Product / Process Change Notification (PCN)	
<input checked="" type="checkbox"/> Major Change <input type="checkbox"/> Minor Change	
PCN Number: PCN_ConCARD_20240923 Affected Series: WR-CARD Affected Order Codes: 693023010811 PCN Date: 2024-06-21 Effective Date: 2024-09-23	Change Category: <input checked="" type="checkbox"/> Equipment/Location <input type="checkbox"/> General Data <input type="checkbox"/> Material <input type="checkbox"/> Process <input checked="" type="checkbox"/> Product Design <input type="checkbox"/> Shipping/Packaging <input type="checkbox"/> Supplier <input type="checkbox"/> Software
Contact: Product Management Phone: +49 (0) 7942 - 945 5001 Fax: +49 (0) 7942 - 945 5179 E-Mail: pcn.eican@we-online.com	Datasheet Change: <input checked="" type="checkbox"/> Yes <input type="checkbox"/> No Attachment: <input type="checkbox"/> Yes <input checked="" type="checkbox"/> No
Description of Change: <p>In order to enhance the product reliability, Würth Elektronik eiSos is switching to a fully automated production line. There will be no change in fit or function of the product.</p> <p>The new revision of the affected order codes will be sent out after the previous revision

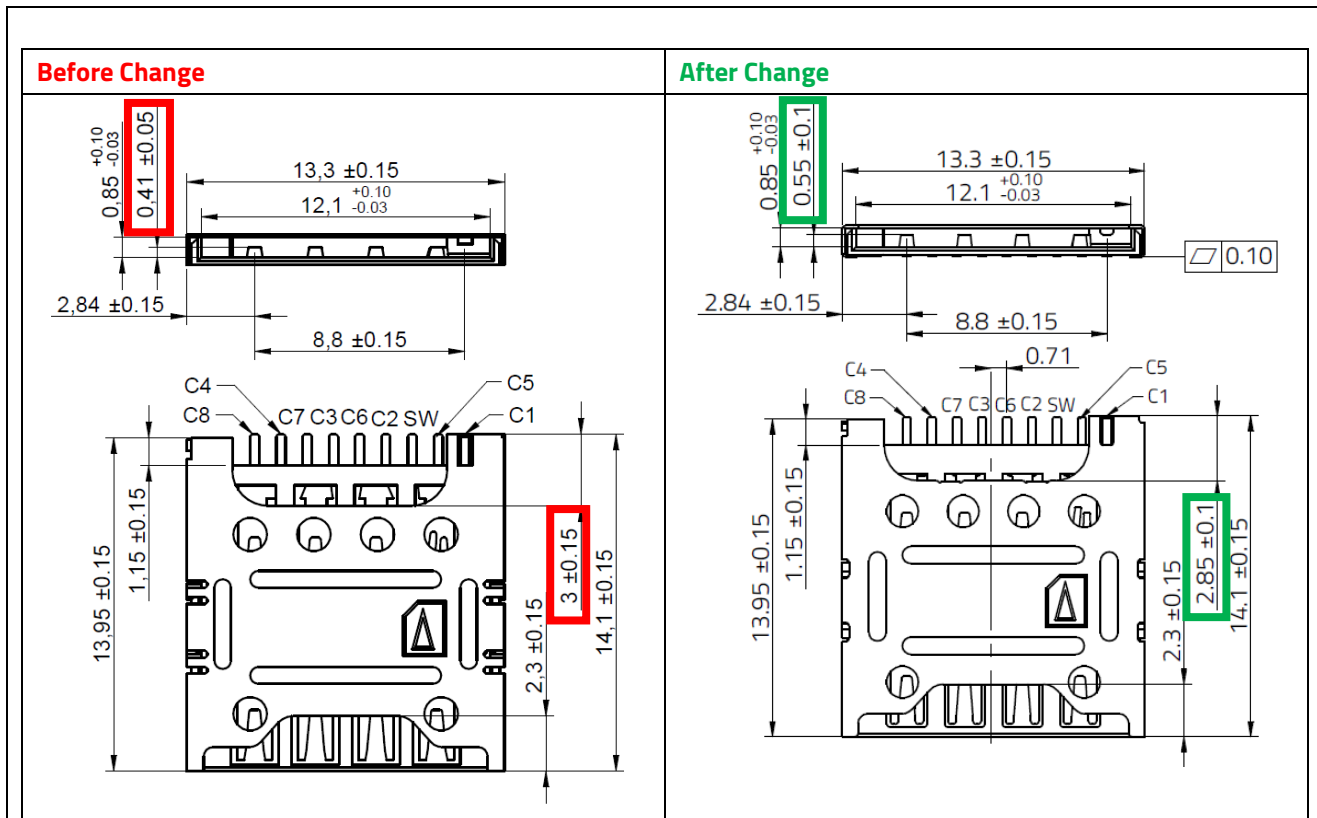
Details of Change: <p>The notable changes are:</p> <ul style="list-style-type: none"> - The tilt of the contacts to ensure a better card retention. - A change in shielding design. The notable dimensional change is the depth of the U-shape near the pins.
